**[Docket No. FAA-2012-0060; Directorate Identifier 2012-NE-02-AD; Amendment 39-17123; AD 2012-14-09]**

**Airworthiness Directives; Pratt & Whitney (P&W) Division Turbofan Engines**

**ACTION:** Final rule.

**SUMMARY:** We are adopting a new airworthiness directive (AD) for certain P&W PW4000 series turbofan engines. This AD was prompted by reports of 3<sup>rd</sup> and 4<sup>th</sup> stage vane fractures in the low-pressure turbine (LPT) of certain PW4000-94" and PW4000-100" turbofan engines. This AD requires dimensional inspections of LPT 3<sup>rd</sup> stage vanes and the rear turbine case, inspection of LPT 4<sup>th</sup> stage vanes at the next LPT overhaul and removal of vanes with non-conforming airfoil fillet radii and vanes with more than one strip and recoat repair. This AD also requires disassembly and reassembly of the 2<sup>nd</sup> stage high-pressure turbine (HPT) rotor and 3<sup>rd</sup> stage LPT rotor at the next HPT and LPT overhauls. We are issuing this AD to prevent 3<sup>rd</sup> and 4<sup>th</sup> stage vane fractures in the LPT, damage to the LPT rotor, uncontained engine failure, and damage to the airplane.

**Figure 1 to Paragraph (e) - Determination of Vane Eligibility**

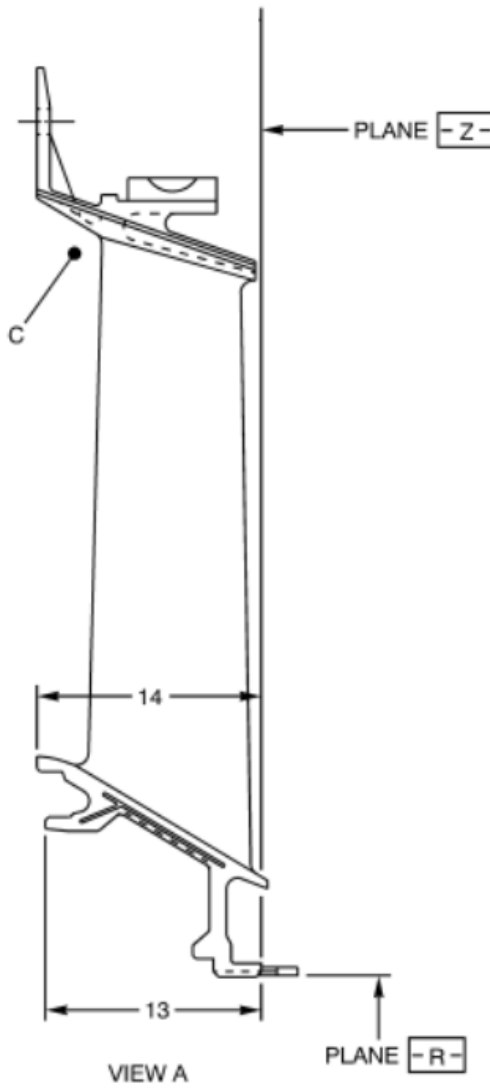
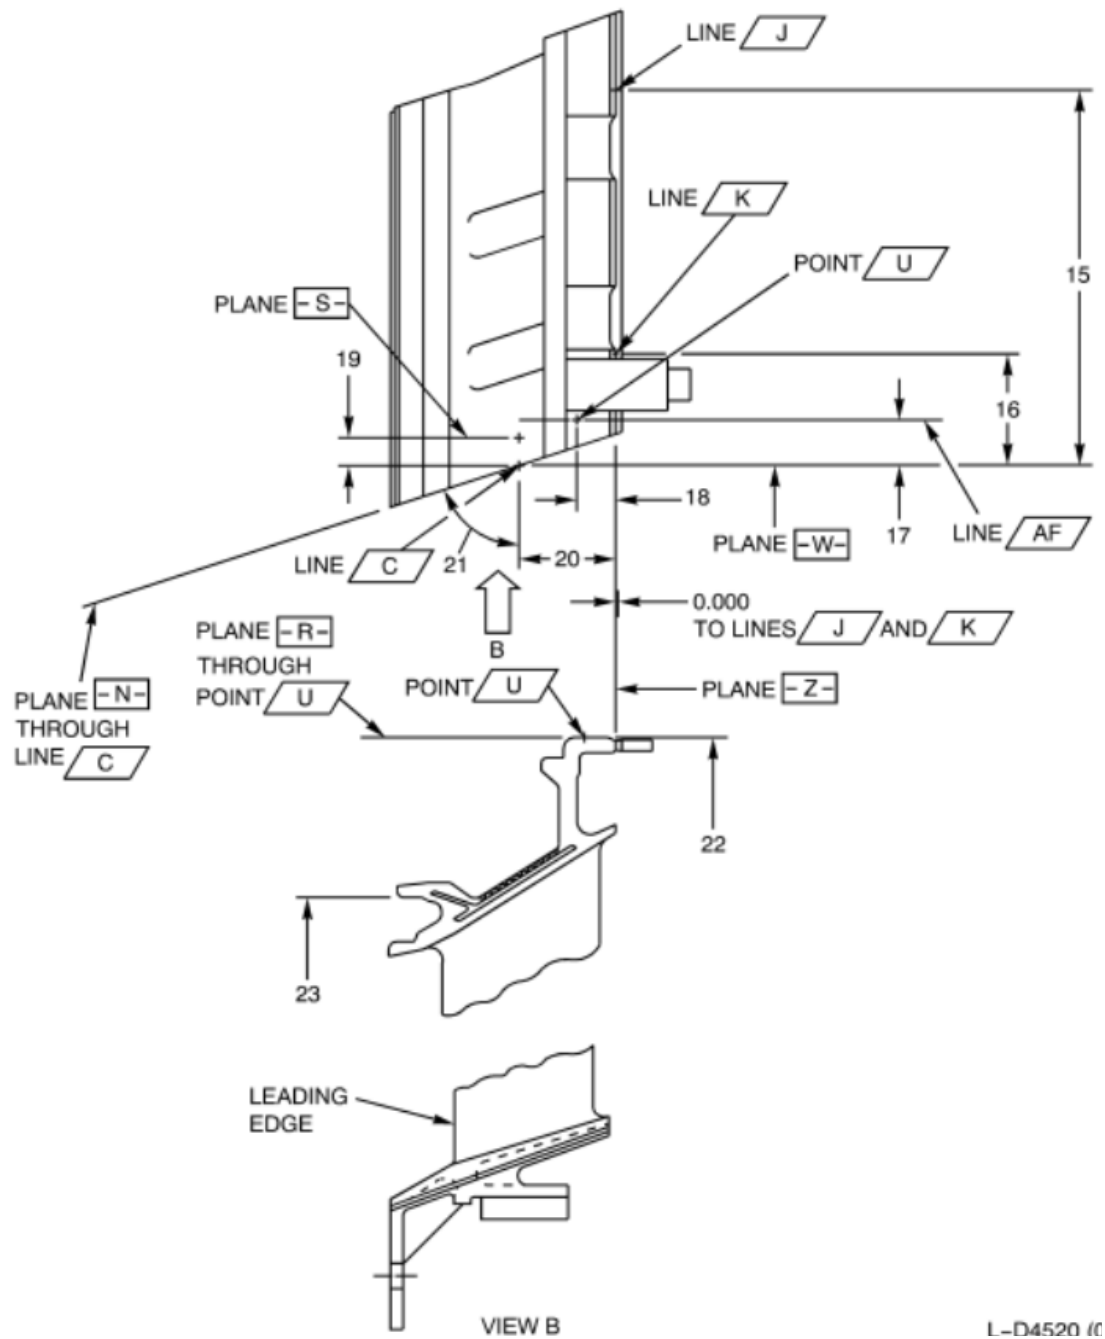
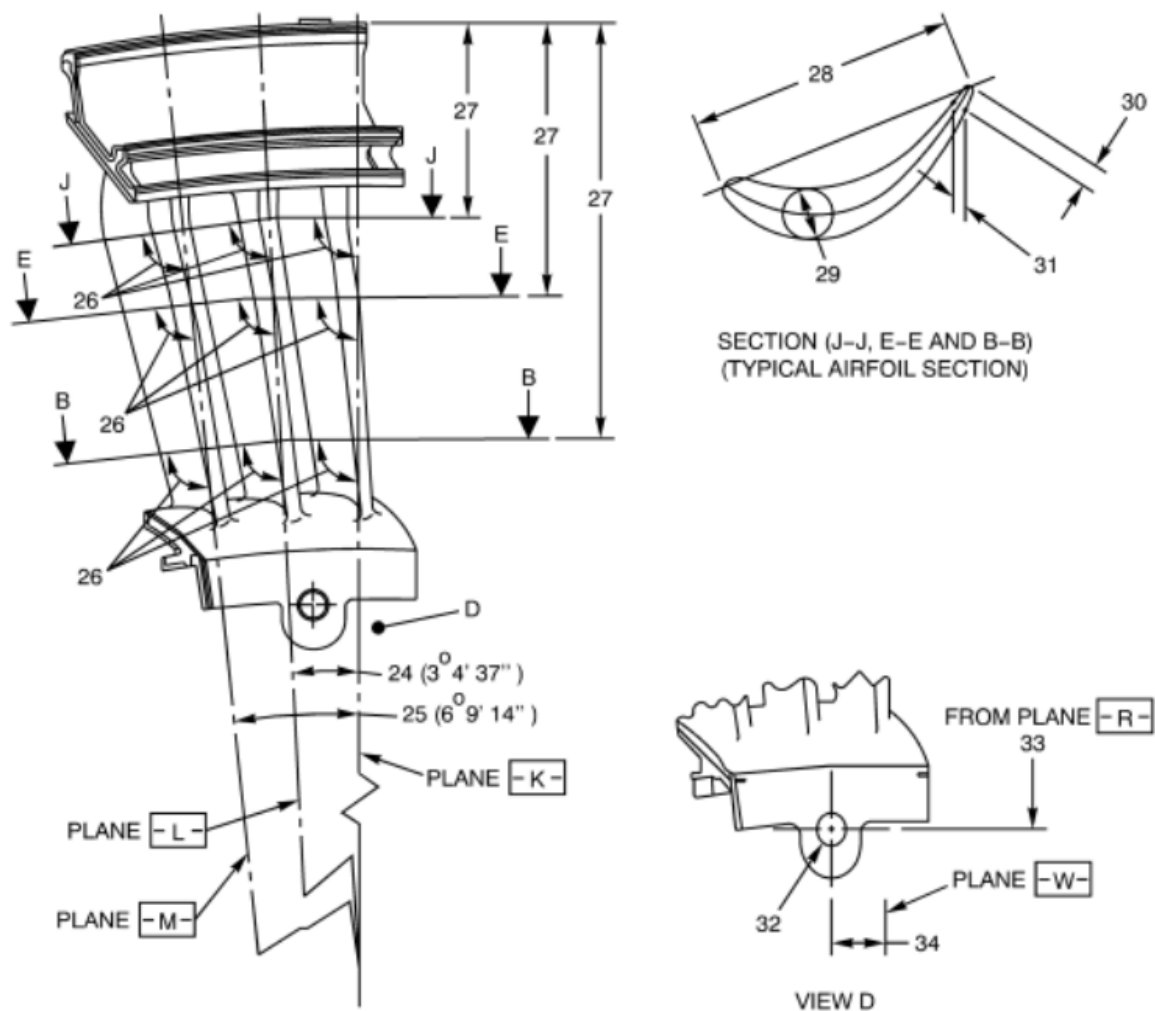
United Airlines requested that in proposed AD paragraphs (e)(1)(iii) and (e)(1)(iv), we change “ensure adequate engagement” to “dimensionally inspect the applicable LPT case slot serviceable dimensions and 3<sup>rd</sup> stage vane serviceable dimensions per the appropriate CIR.” The commenter also requested that we list the specific dimensions to inspect by index number. The commenter stated that no mechanic can deduce what an adequate engagement is because it is not specific enough.

(iii) Dimensionally examine index 13 through index 34 of the LPT 3<sup>rd</sup> stage vane cluster assembly. Use Table 2 to paragraph (e) of this AD and Figure 1, Figure 2, and

Figure 3 to paragraph (e) of this AD to determine whether the vane is eligible for installation.

We agree. We changed paragraph (e)(1)(iii) to “dimensionally examine index 13 through index 34 of the LPT 3<sup>rd</sup> stage vane cluster assembly.” We also changed paragraph (e)(1)(iv) to “dimensionally examine index 23 and index 24 of the vane engagement slots on the rear turbine case, where the 3<sup>rd</sup> stage vane is installed.” We also listed the specific dimensions to inspect by index number, and included the supporting figures in this AD.

**Figure 4 to Paragraph (e) - Determination of Case Eligibility**

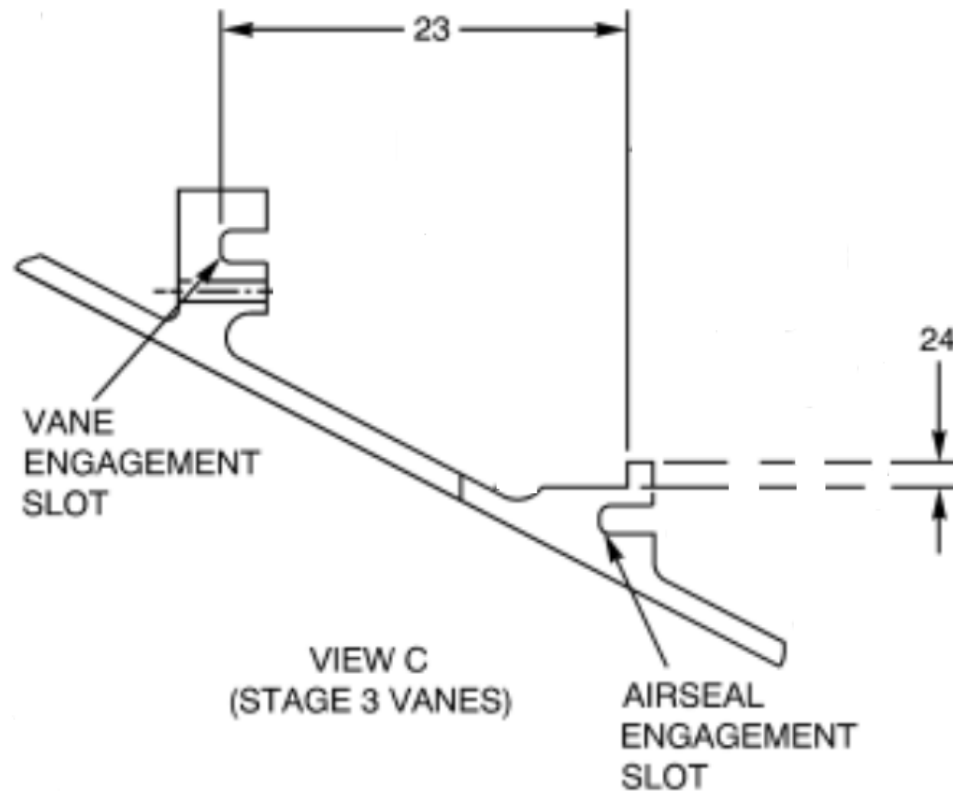
(iv) Dimensionally examine index 23 and index 24 of the vane engagement slots on the rear turbine case, where the 3<sup>rd</sup> stage vane is installed. Use Table 3 to paragraph (e) of this AD and Figure 4 to paragraph (e) of this AD to determine whether the case is eligible for installation.

Inspect:	Eligible for Installation Limits
23	1.875 inch (47.625 mm) minimum
24	0.097 inch (2.464 mm) minimum
